# Errata to MPC8315E PowerQUICC II Pro Integrated Host Processor Family Reference Manual, Rev. 2

This errata describes corrections to the *MPC8315E PowerQUICC II Pro Integrated Host Processor Family Reference Manual*, Revision 2. For convenience, the section number and page number of the errata item in the reference manual are provided. Items in bold are new since the last revision of this document.

Figure 9-1. DDR Memory Controller Simplified Block Diagram

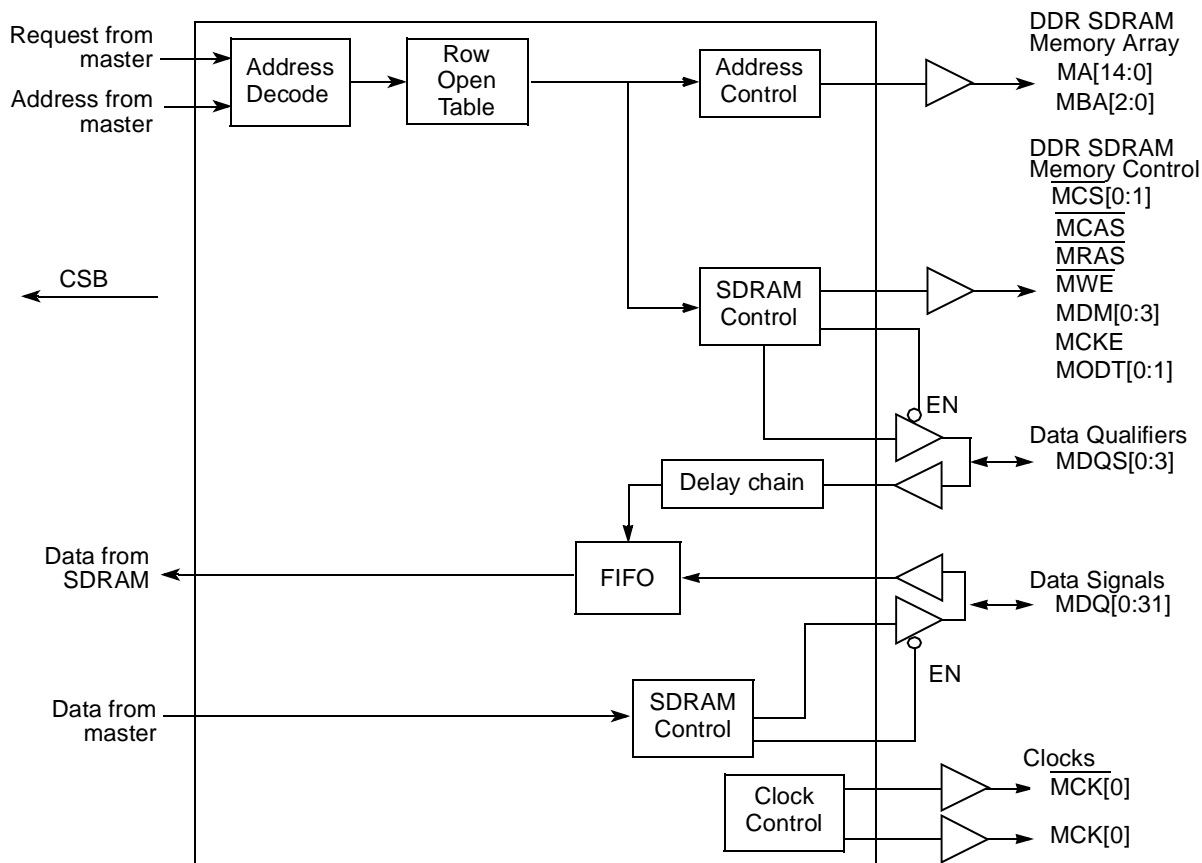
Update Figure 9-1, “DDR Memory Controller Simplified Block Diagram,” to show as follows:

Figure 9-22. DDR Memory Controller Block Diagram

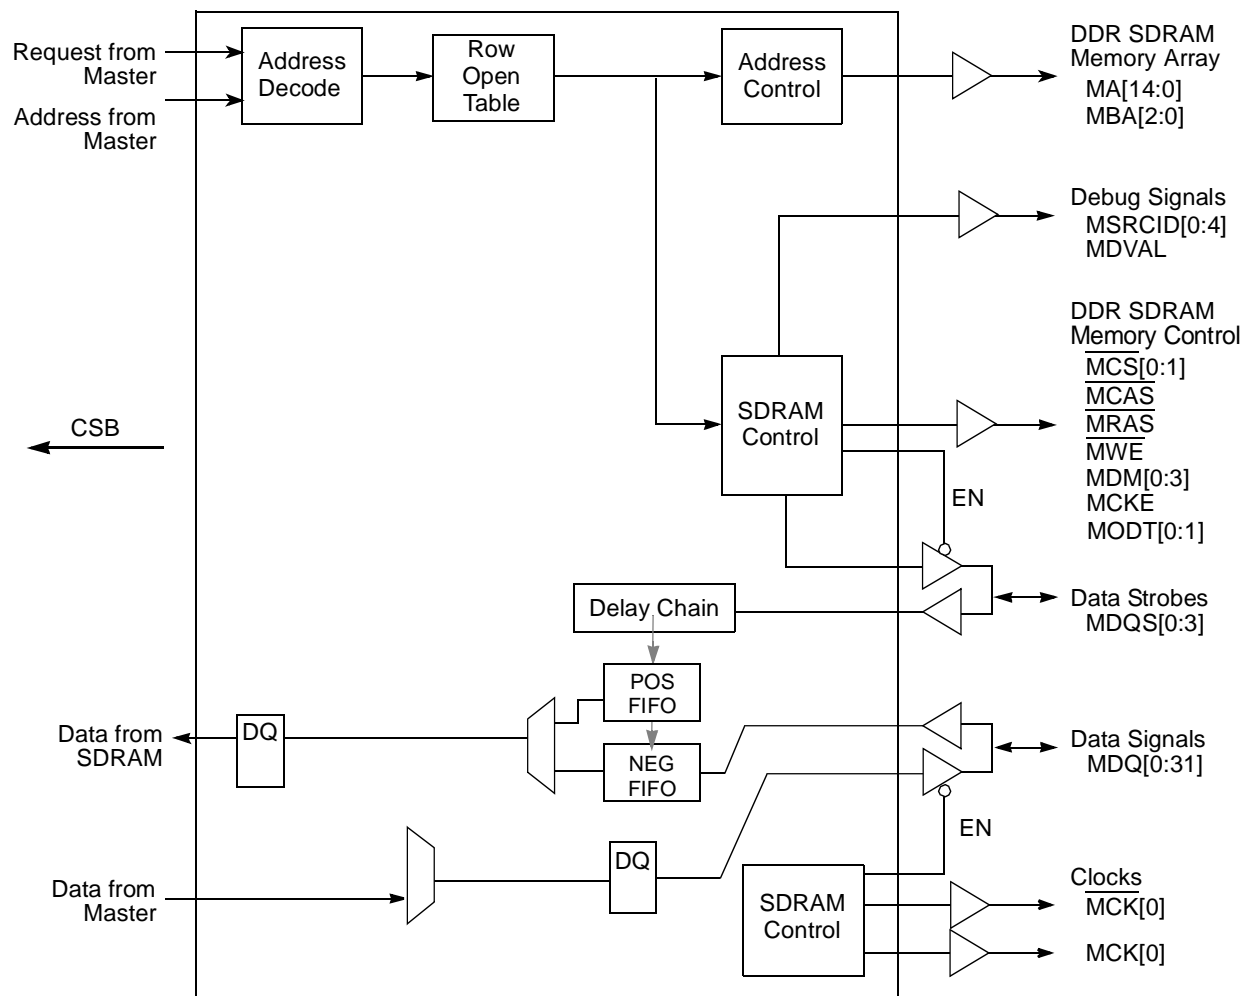
Modify Figure 9-22, “DDR Memory Controller Block Diagram,” to show as follows:

Figure 17-54. General Structure of EHCI Periodic Schedule Utilizing Interrupt Spreading

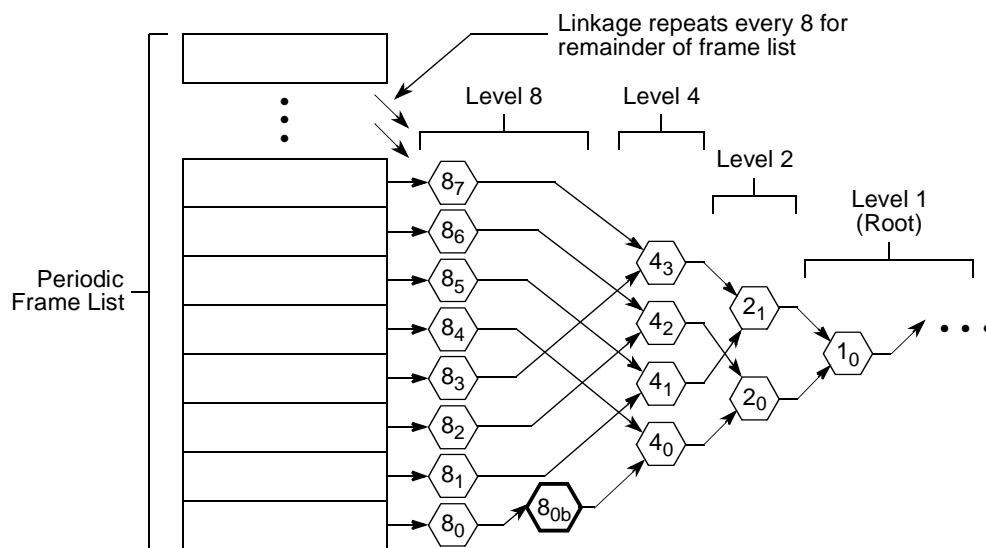
In Figure 17-54, “General Structure of EHCI Periodic Schedule Utilizing Interrupt Spreading,” change the notations of the nodes to show as follows:

Figure 17-55. Example Host Controller Traversal of Recovery Path via FSTNs

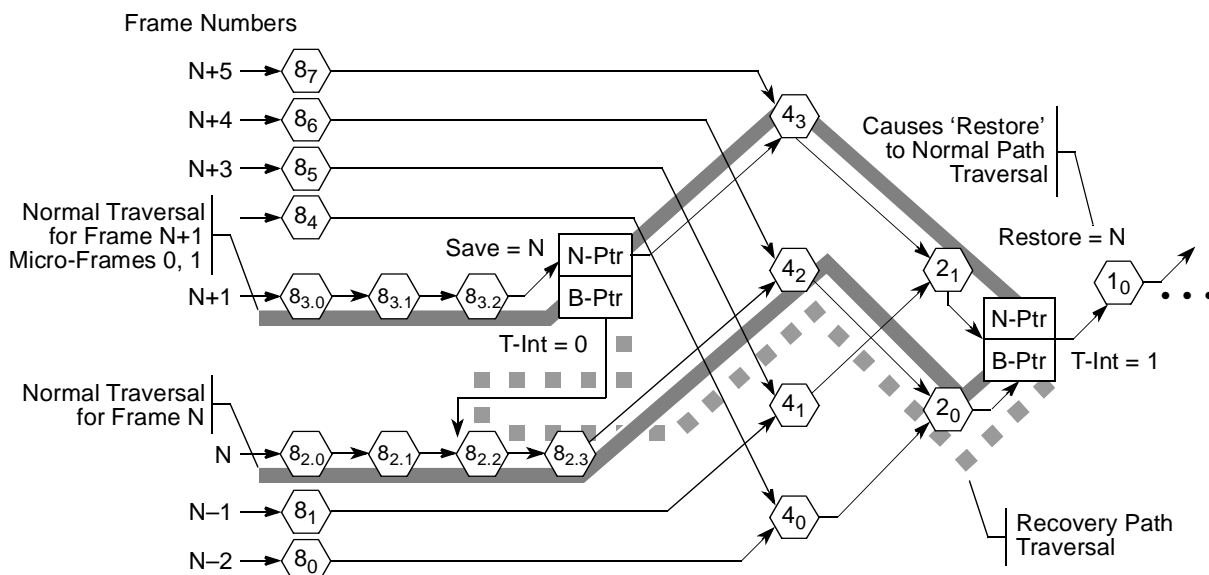
17.6.12.2.2, 17-100 In Figure 17-55, “Example Host Controller Traversal of Recovery Path via FSTNs,” change the notations of the nodes to show as follows:

Figure 17-56. Split Transaction State Machine for Interrupt

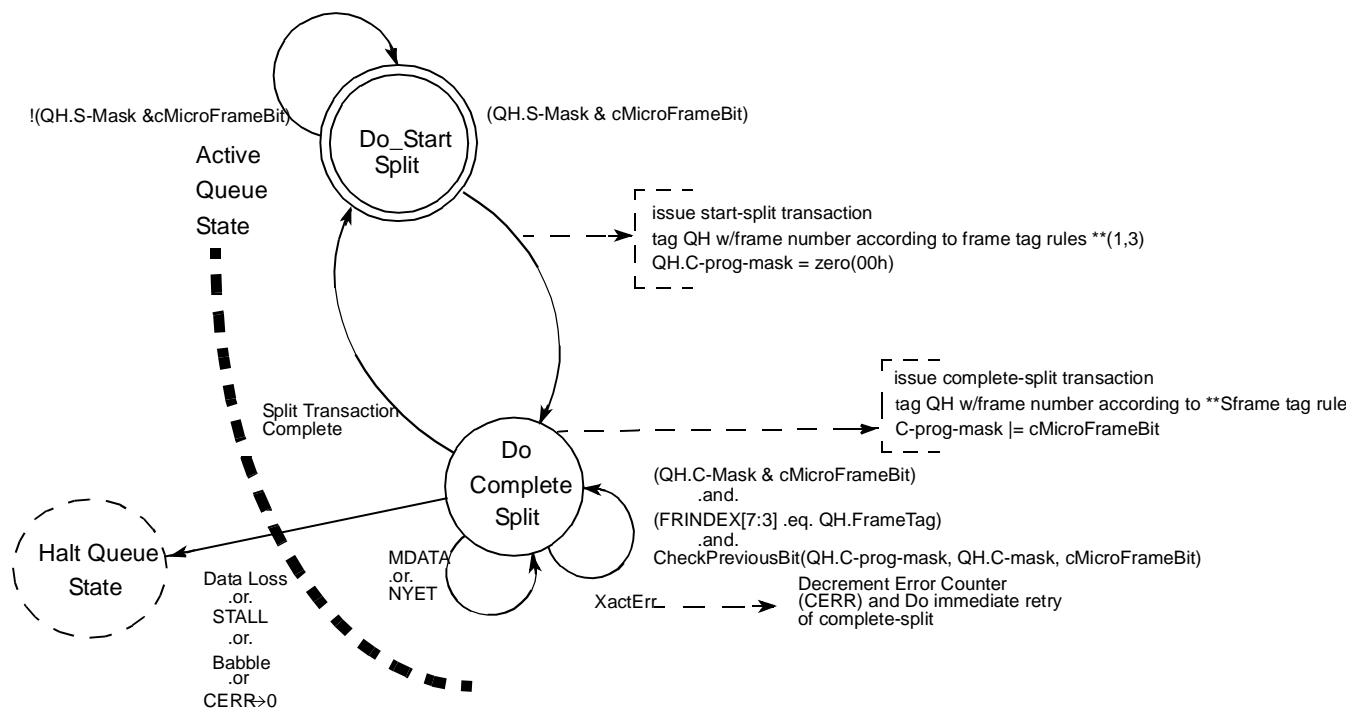
17.6.12.2.5, 17-103 Modify Figure 17-56, “Split Transaction State Machine for Interrupt,” to show as follows:

**Figure 17-59. Split Transaction State Machine for Isochronous**

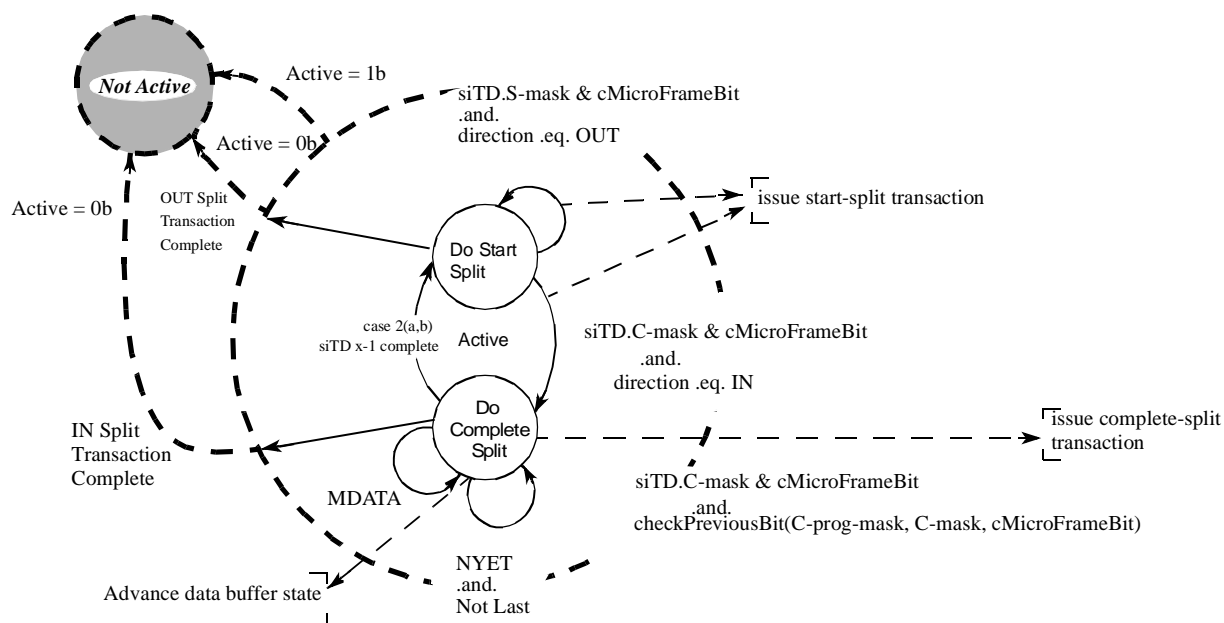
17.6.12.3.3, 17-115      Modify Figure 17-59, “Split Transaction State Machine for Isochronous,” to show as follows:

**Figure 17-64. Endpoint Queue Head Diagram**

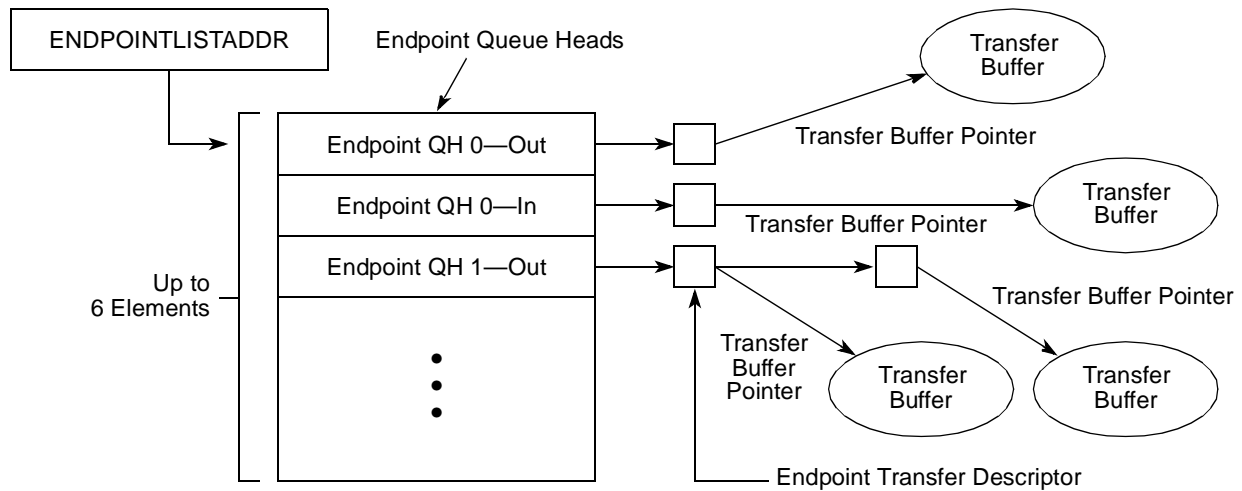
In Figure 17-64, “Endpoint Queue Head Diagram,” replace “Up to 32 Elements” with “Up to 6 Elements” to show as follows:
